1955 Corvette: Service Bulletin: Hard Shifting

SUBJECT: HARD SHIFTING - 1955 MODEL
PASSENGER CAR
3-SPEED TRANSMISSION

BULLETIN No. DR #236

FIGURE I

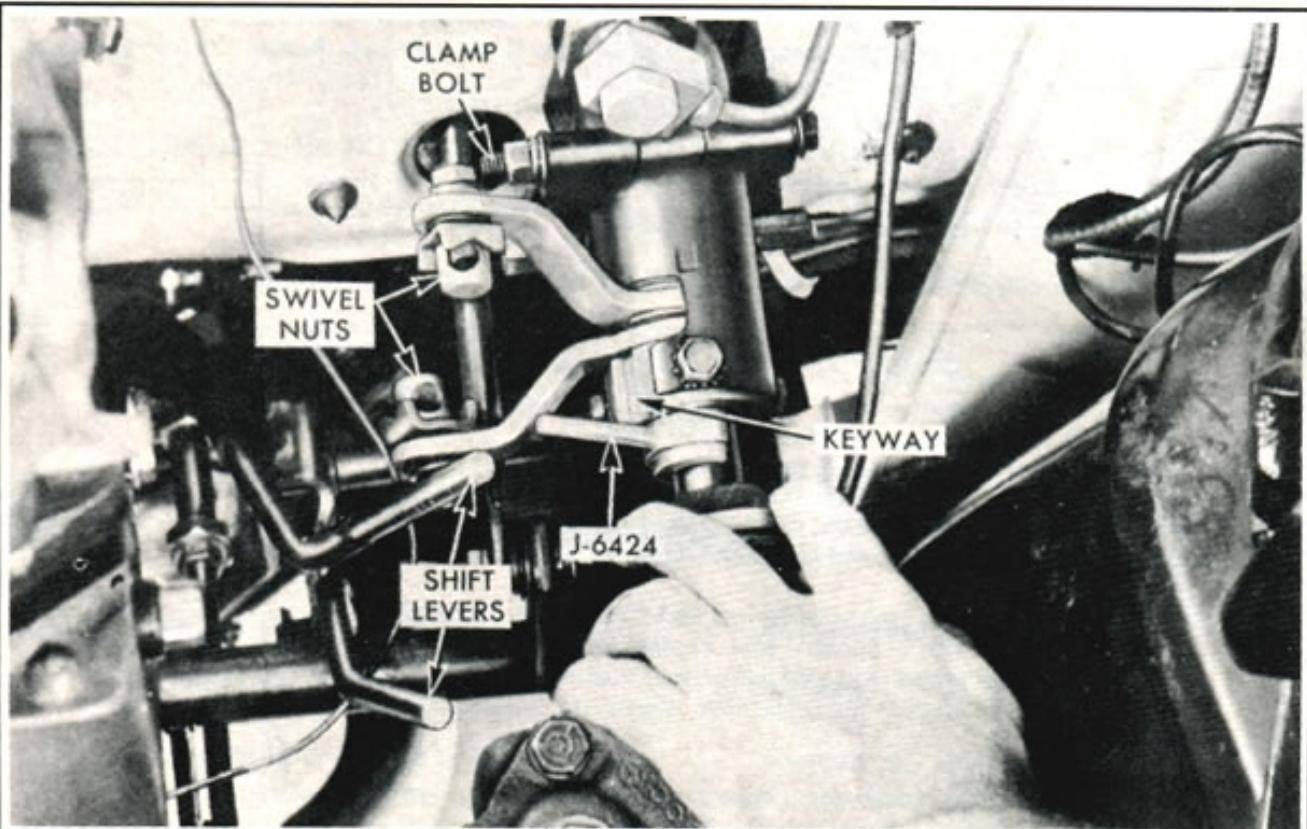
13. Insert gearshift rod ends in swivels - transmission must be in neutral detent in both ranges. Do not tighten.
14. Install alignment gauge J-6424 inserting side stamped "STD" between steering mainshaft and shifter tube in key area. This sets the required 1/16 eccentricity in proper relation to the key on shifter tube. See figure 1.

FIGURE 2

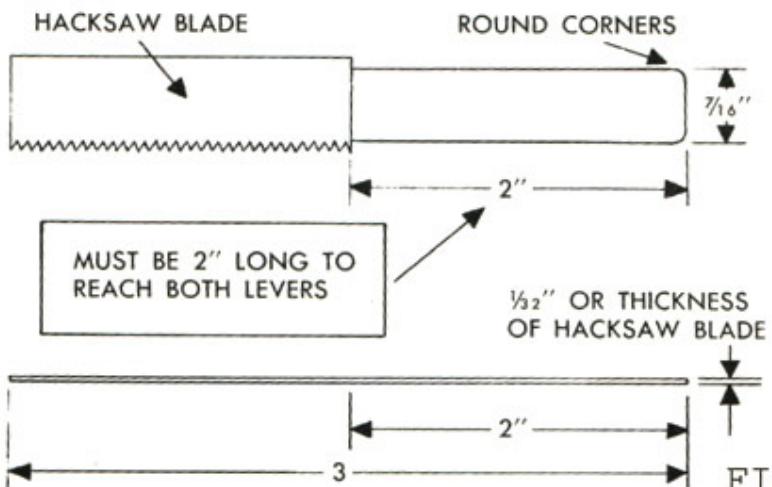
- c. Remove alignment gauge.
16. Make and insert special blade gauge, see figure 2, thru adjusting ring slot, lower levers and gate washer. Tighten swivels on gearshift rods while holding downward lightly on lower levers. Transmission must be in neutral detent at this time.

FIGURE 3

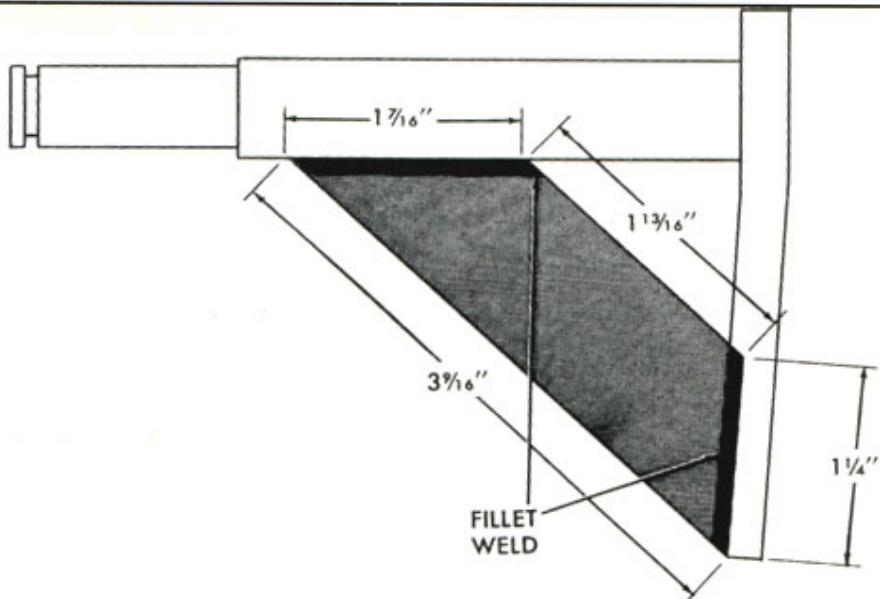
Further improvement of shifting can be made by reinforcement of transmission control rod idler lever support located on left frame rail under toe pan to reduce its deflection. See figure 3.
